Rezoning Transportation Analysis

Petition Number: 2020-046

General Location Identifier: Tax ID 20103128

Date	Description
04-21-20	First Review
05-20-20	Second Review (FO)

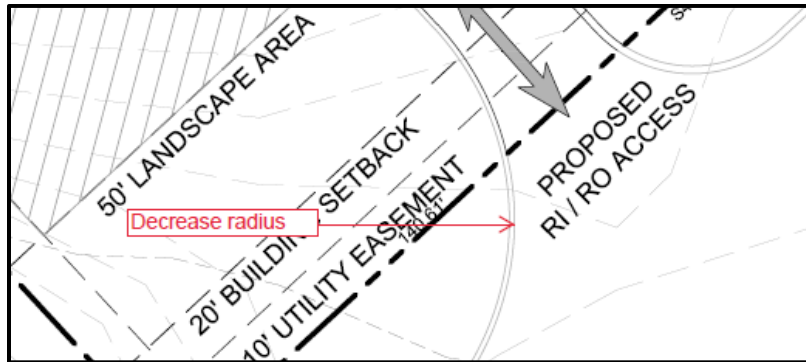
- 3. Technical Correction Site Plan (5/28/2020)** The petitioner should revise the site plan and conditional note(s) to preserve the existing driveway as **right-out only**. Per NCDOT, a right-in/right-out driveway will affect the functionality of the intersection. Please provide CDOT with any other correspondence that the petitioner has had with NCDOT, since plans to convert this access to right-in/right-out were already submitted to the city for permitting review within Accela: LDC-2019-00062 - Leon Whitehall.
